HISTORIC LANDMARK COMMISSION
STAFF REPORT

Terrace Falls Sun Deck
PLNHLC2014-00576 & PLNHLC2014-00823
171 East 3rd Avenue
January 15, 2015

West Elevation - proposed

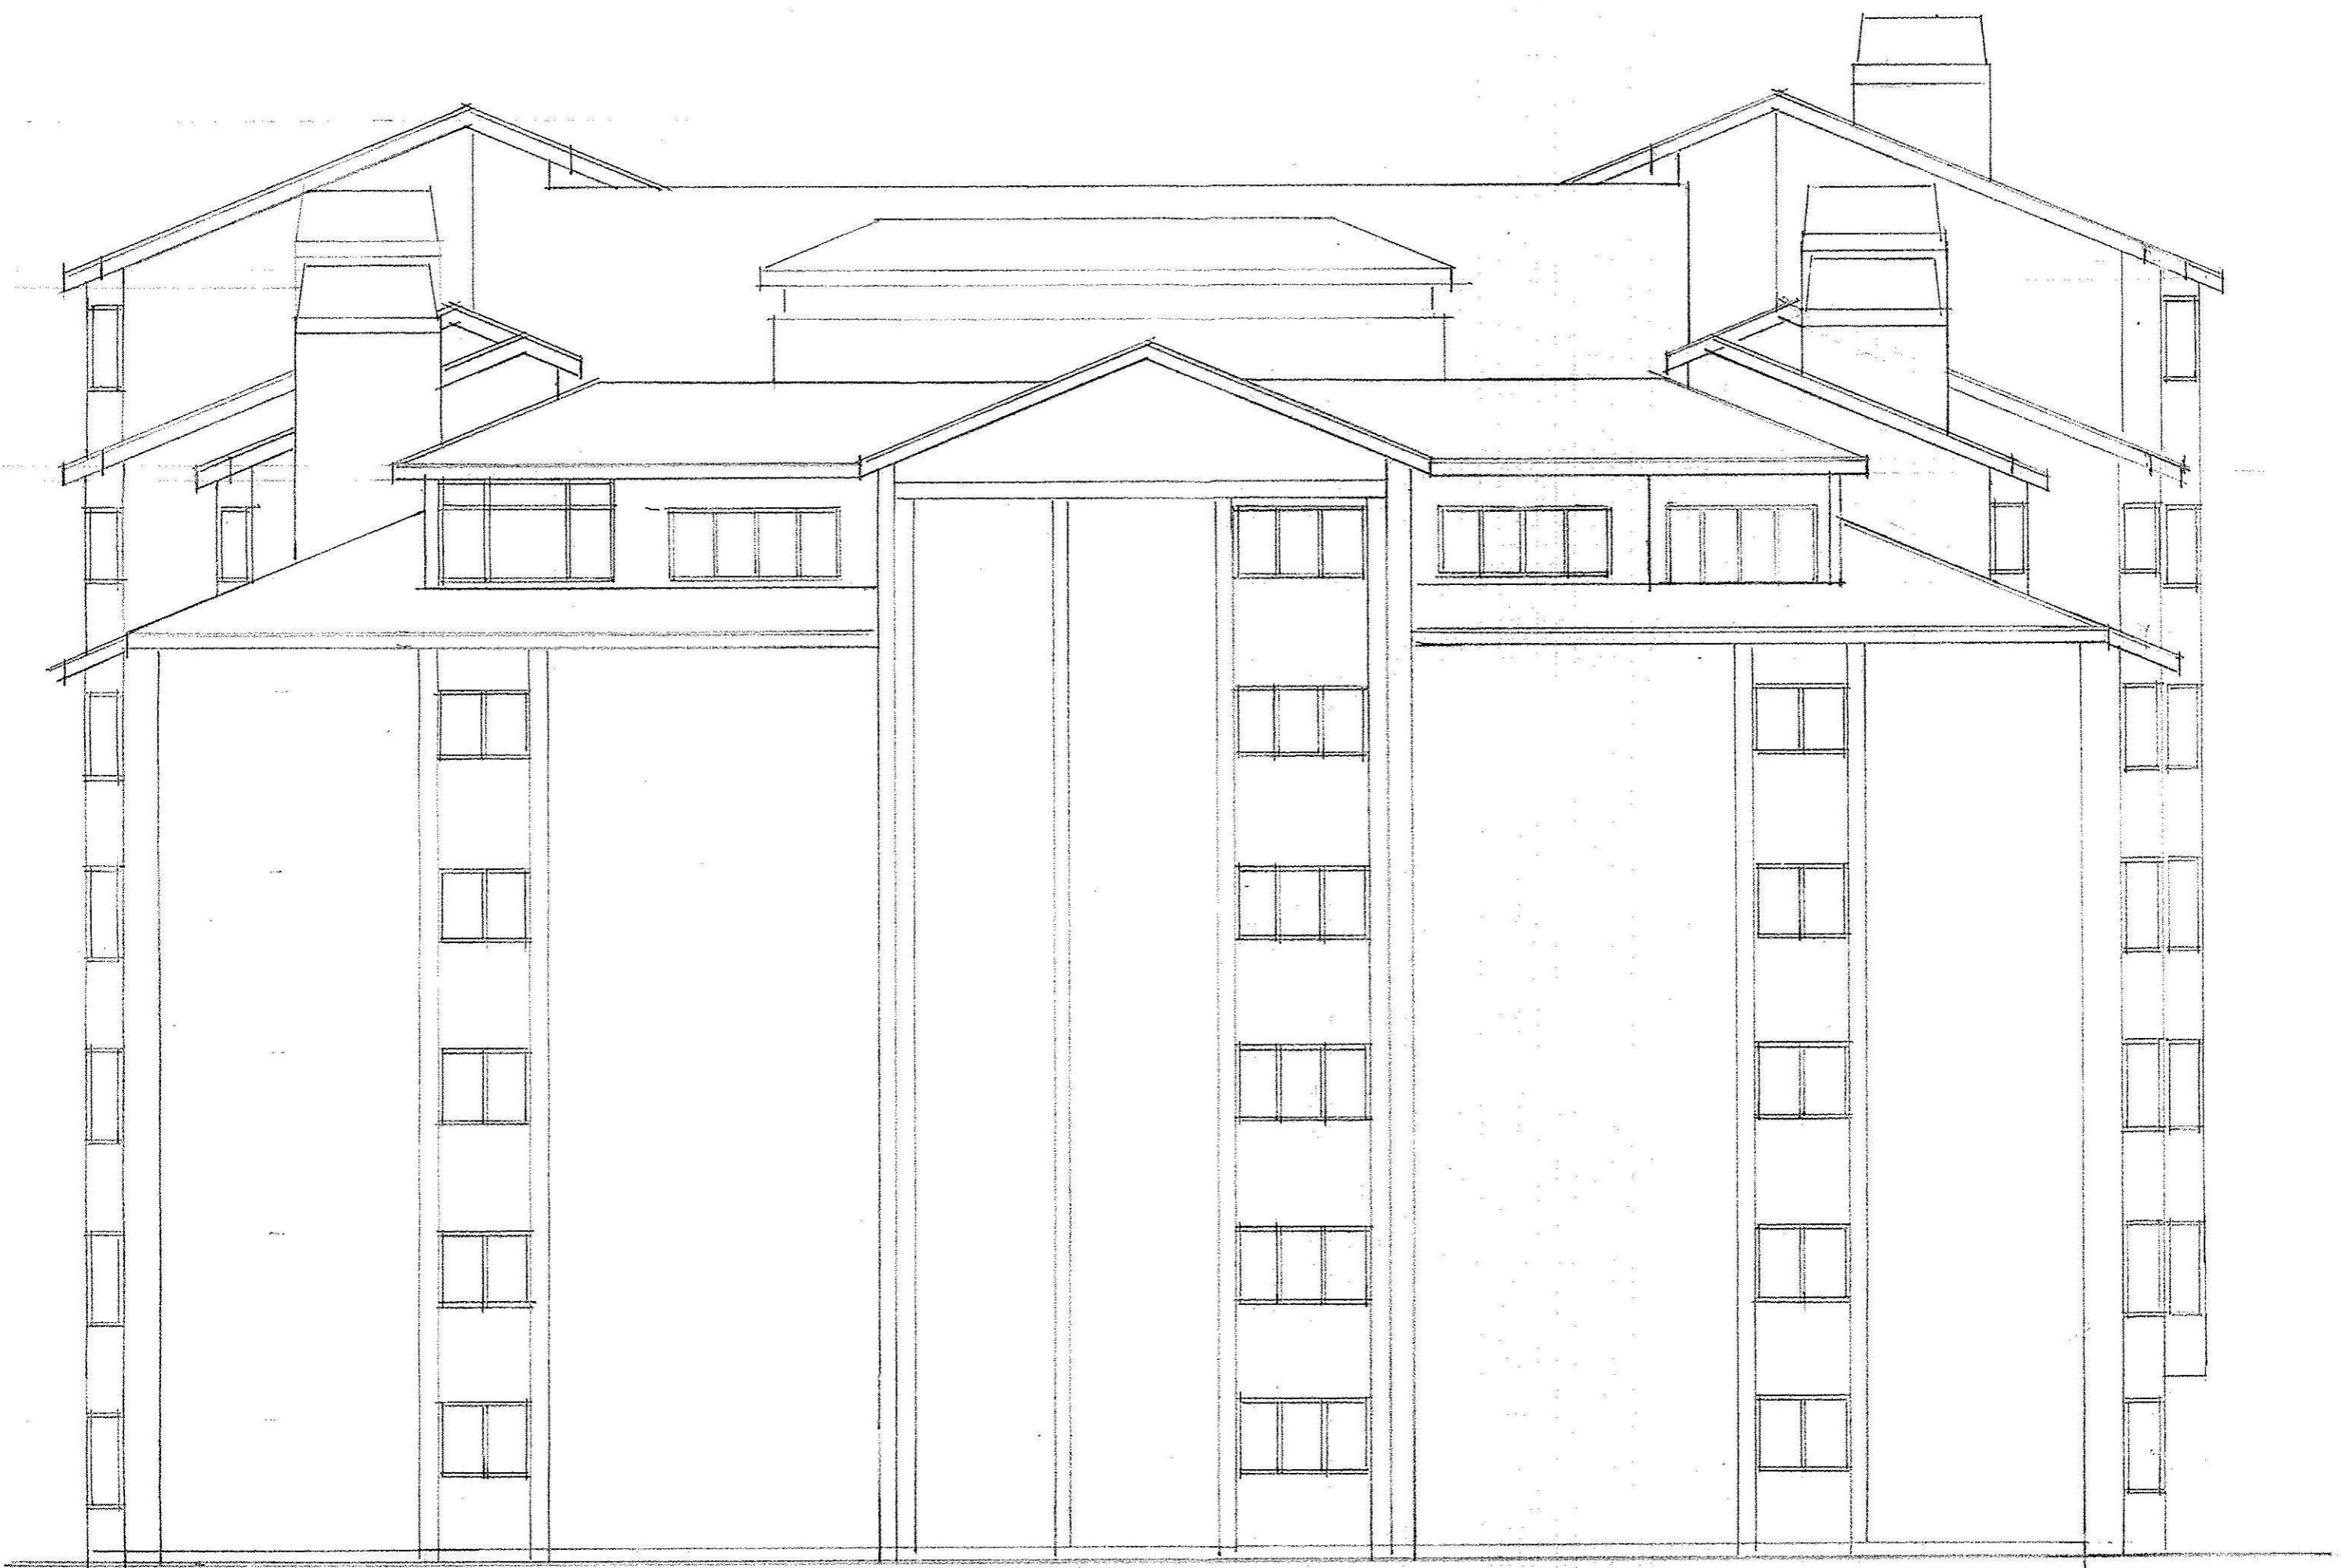
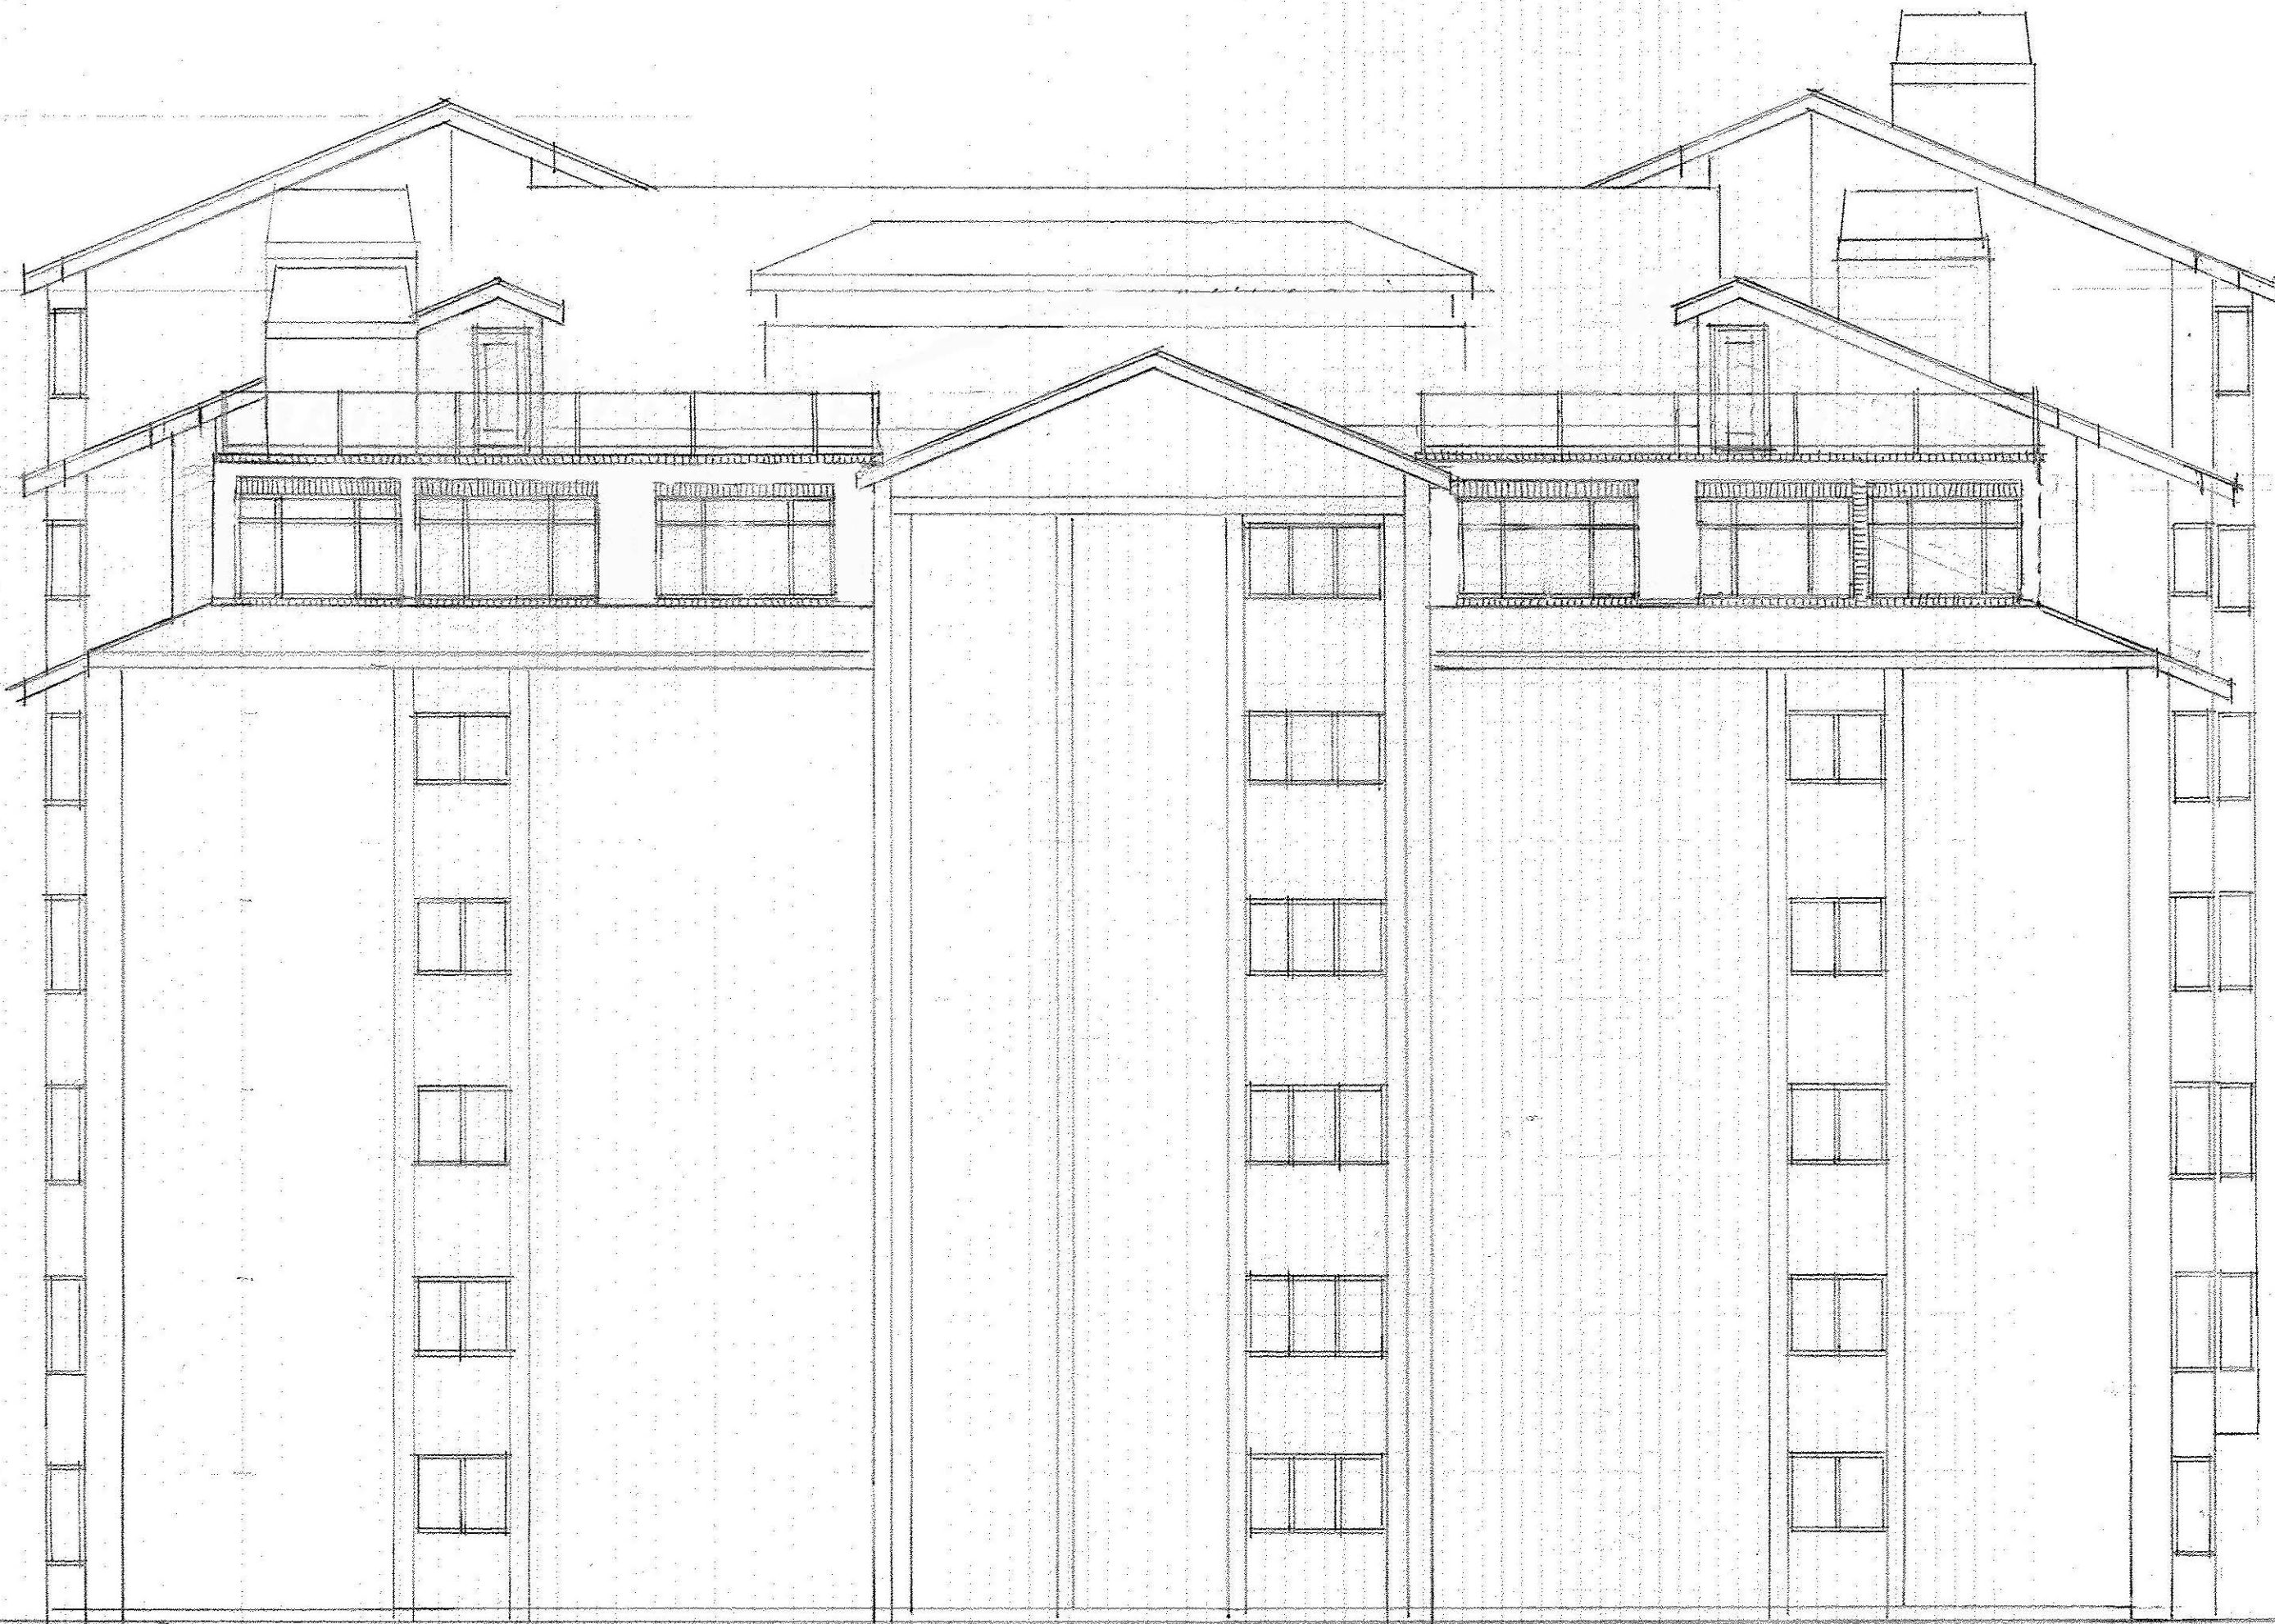
The top level is already distinct from the levels below. The subject unit is substantially setback from the units below and is unique in that it has a covered balcony which has been enclosed. The proposed change of the roofline will be compatible with and to scale with the existing roofline patterns which are made up of multiple roof heights. The additional roof height will not be readably visible from the street because it will be setback as an extension of a sloping roof.

The distinct top floor units on the end are proposed to assist in terminating the façade, and complement the architectural hierarchy and create coherent visual interest. The proposed project maintains the existing modulation. The proposed deck is a module that will be in scale with the existing modulation of

The proposed new railing on the deck will be wrought iron similar to the railings on remaining open balconies. The transparency of wrought iron railing will help reduce the impact of the extension of the walls in the corners and avoids the need for a solid balcony component.

Finding: The changes proposed will be visually compatible with the building in terms of mass and scale. Staff finds that the proposed changes meet the standard.
